915 e spruce streetDesign Review Recommendation
October 26, 2016

SDCI Project # 3022495

Proposal for a new 75-unit residential building 7 stories above grade with rooftop amenity area. No on-site parking is proposed due to proximity of transit service

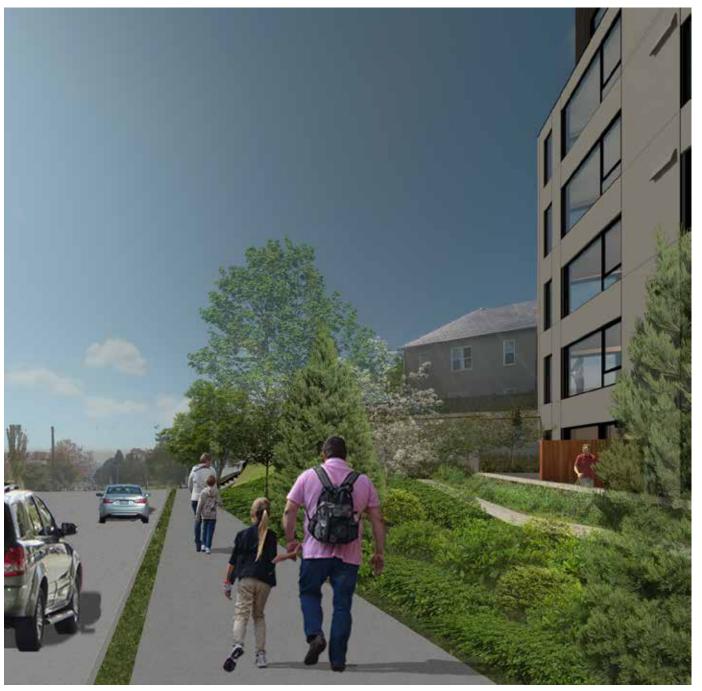
- direction: "simplify the panelized siding to avoid creating an overly busy material application and allow the emphasis to be given to the stair element"

- direction: "further develop integration of the staircase element into the design concept" and "further examine architectural detailing [of the stair] to enhance the design"

response: with the simplification of the primary siding, the exterior stair is now the main design element at the NE corner, emphasized through warm-toned accent siding material (corrugated preweathered steel)

response: the exterior stair anchors the NE corner, reinforced by surrounding walls that project slightly past the primary building walls to form a shield-like expression. Additional detail on the stair construction and siding is provided in the imagery below v

^ Boren Ave, walking south with improved sidewalk and new added street trees

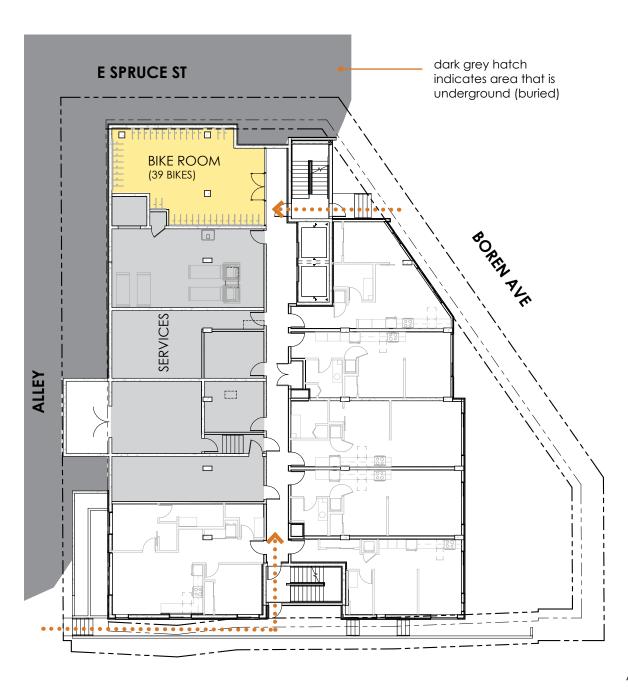
- direction: "supported the raised planter along Boren as means to buffer the residential building...[and] stressed the importance of significant landscaping to mitigate removal of existing trees"

response: the raised bioretention planter remains between the ground floor patios and Boren Ave Four new street trees have been added along the Boren sidewalk, which will be <u>electively</u> improved/widened by the project. In addition to the street trees, new trees are proposed between the building and Boren

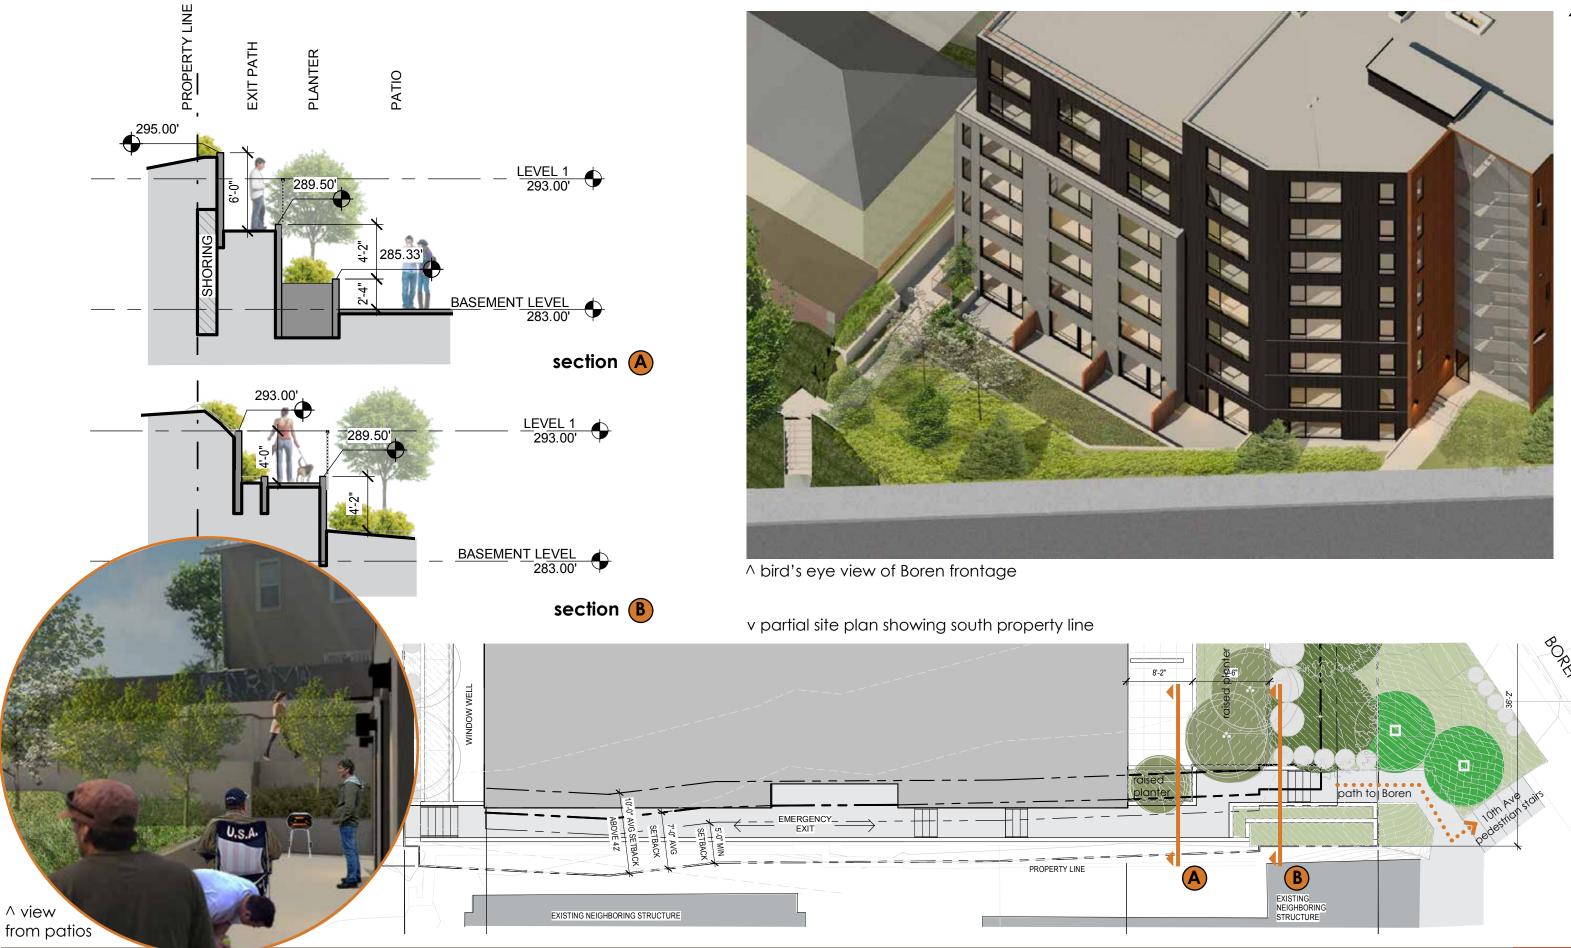
- direction: "soften the appearance of the [southeast] retaining wall"

response: the retaining wall has been terraced to reduce the visual height, and trees are proposed in front of the lower portion of the wall to soften its appearance

lower level patios, looking SE towards Boren and retaining wall (privacy screens between patios omitted for clarity)>

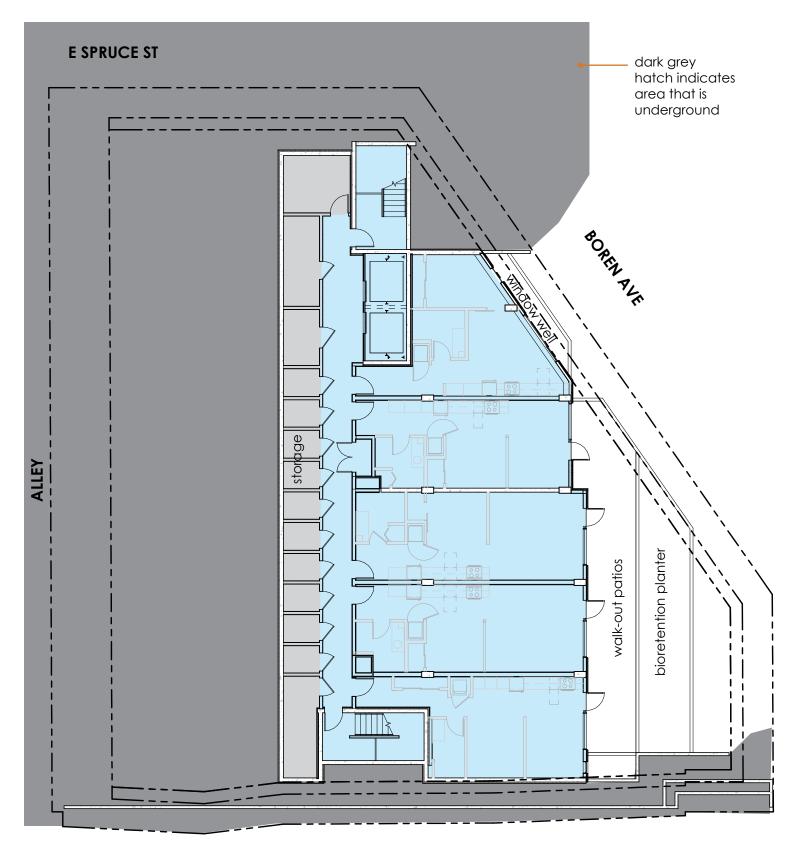
- direction: "requested additional sections/information to better understand the relationship of the ground floor units, excavated patio, and retaining wall"

response: sections and more detailed perspective views are included on this page and next
